**Review of Dominion Energy South Carolina,  
Incorporated's 2021 Integrated Resource  
Plan Docket Nos. 2019-226-E & 2021-9-E**

South Carolina  
Office of Regulatory Staff

December 15, 2021

Prepared by the South Carolina Office of Regulatory Staff  
and  
J. Kennedy and Associates, Inc.

**Figure 1 – Modeled DSM Costs**

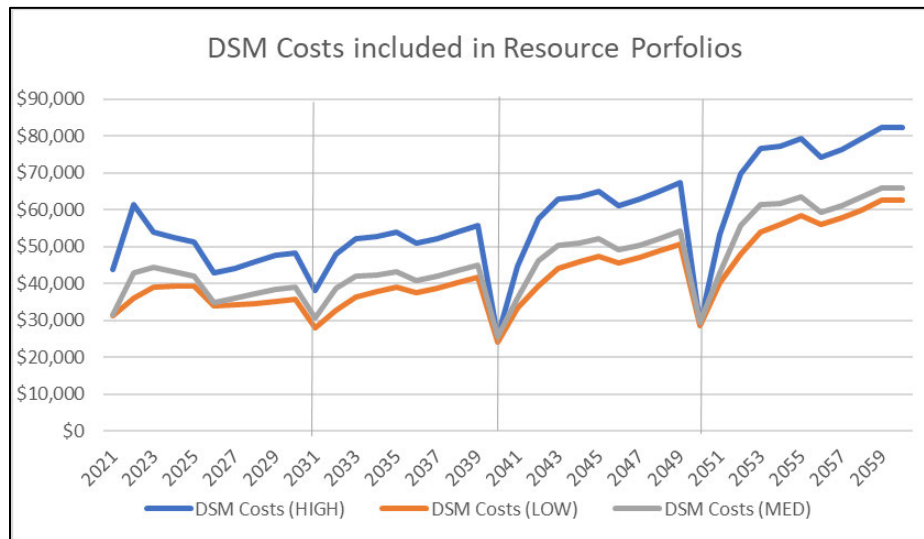
Ordering paragraph 8 of Order No. 2021-429 required DESC to, "present realistic and levelized DSM costs in all future IRPs starting with the 2021 IRP Update." No additional information was contained in the Commission's Order. However, the Joint Intervenors' comments to DESC's Modified 2020 IRP explained that "DESC modeled EE costs after 2029 in a way that produces a cost stream that has significant price swings over the

period 2030 to 2059,” because as the Joint Intervenor’s explained, “every ten years the costs restart with 2021 EE costs....”<sup>50</sup>

The following figure demonstrates the price swings and the repeated pattern of modeled DSM costs, which were used by the Company in the 2021 IRP Update.

The Company did not modify its forecasted DSM costs or expected savings from the Modified IRP to the 2021 IRP Update. As a result, the forecasted DSM costs remain the same and are not levelized as shown by the periodic cost dips in 2031, 2041 and 2051.

**Figure 2 – Gas Forecast Comparison (Base Case)**

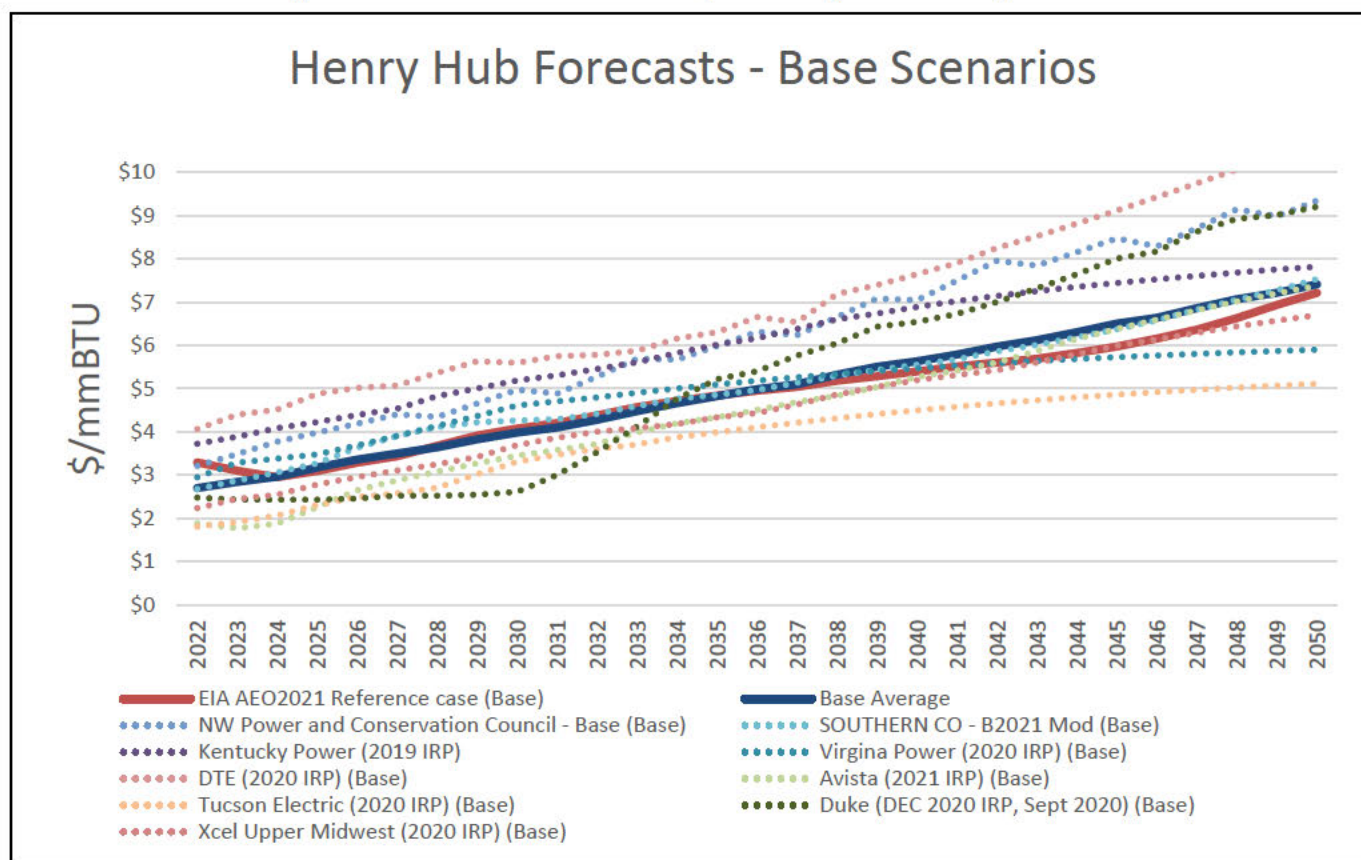
DESC's forecasts appear to be reasonable. The figure below compares DESC's EIA based reference forecast to recent forecasts from Avista,<sup>62</sup> Detroit Edison, Duke Carolinas,<sup>63</sup> Kentucky Power,<sup>64</sup> Northwest Power and Conservation Council,<sup>65</sup> Southern Company,<sup>66</sup> Tucson Electric,<sup>67</sup> Virginia Power<sup>68</sup> and Xcel Upper Midwest.<sup>69</sup>

The Company should continue to update natural gas forecasts utilizing recent market data and study information as available. Regarding CO<sub>2</sub>, the Company's concern that a \$35/ton CO<sub>2</sub> forecast may be extreme may be legitimate. However, ORS is aware that extreme CO<sub>2</sub> forecasts are considered by modelers for planning purposes in the industry. ORS recommends that extreme CO<sub>2</sub> forecasts be discussed as part of the Stakeholder Working Group.
